Access Compliance Report

Public Rights-of-Way

(Curb Ramps)

Intersection ID: 50592	Main Street: BENDING_BRANCH_RD	Cross Street: BRISTLEY_RD	Location: SE
ADA ID: BE9E933658DC	Ramp Type: Perp	Initial Pass/Fail: Pass	Overall Compliance: No
Severity Score: 5			
Codes/Mitigation Info/Possible Solution		Field Measurements/Component Compliance

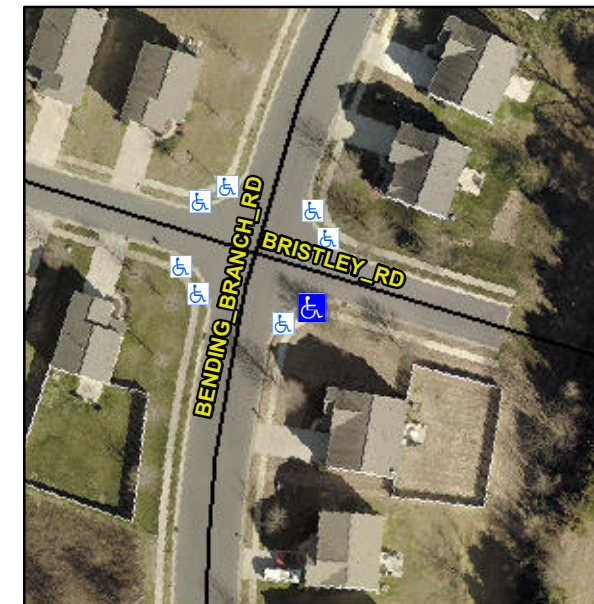
**Not Found, R304.2.2-Perp, R304.3.2-
Para, R305.2, R304.5.4**

Compliance	Description	Data	Compliance	Description	Data
N/A	Ramp Length (in)	47.0	Yes	Ramp Slope (%)	7.3
Yes	Ramp Width (in)	48.0	Yes	Ramp XSlope (%)	0.7
N/A	Flare Type LT	Sloped	N/A	Flare Type RT	N/A
N/A	Flare Slope LT (%)	4.7	N/A	Flare Slope RT (%)	7.2
N/A	Flare Traversable LT?	No	N/A	Flare Traversable RT?	No
Yes	Landing Length (in)	48.0	Yes	DWS Provided?	Yes
Yes	Landing Width (in)	84.5	Yes	DWS Contrast?	Yes
No	Landing Slope (%)	2.2	Yes	DWS Length (in)	24.0
Yes	Landing X Slope (%)	1.4	Yes	DWS Full Width?	Yes
N/A	Landing Curb? (Y/N)	No	No	DWS Offset (in)	5.0
N/A	Shared Landing?	Yes			
Yes	Gutter Ponding?	No	No	Gutter Slope (%)	13.5
Yes	Gutter Lip Ht (in)	0.0	Yes	Gutter X Slope (%)	0.3
N/A	Painted X Walk1?	No	N/A	Painted X Walk2?	N/A
	X Walk 1 Direction	To N		X Walk 2 Direction	N/A
N/A	X Walk 1 Width (in)	N/A	N/A	X Walk 2 Width (in)	N/A
	X Walk 1 Slope (%)	2.3		X Walk 2 Slope (%)	N/A
	X Walk 1 X Slope (%)	1.6		X Walk 2 X Slope (%)	N/A

**Remove & Replace Entire Ramp.
Remove & Replace Gutter.**
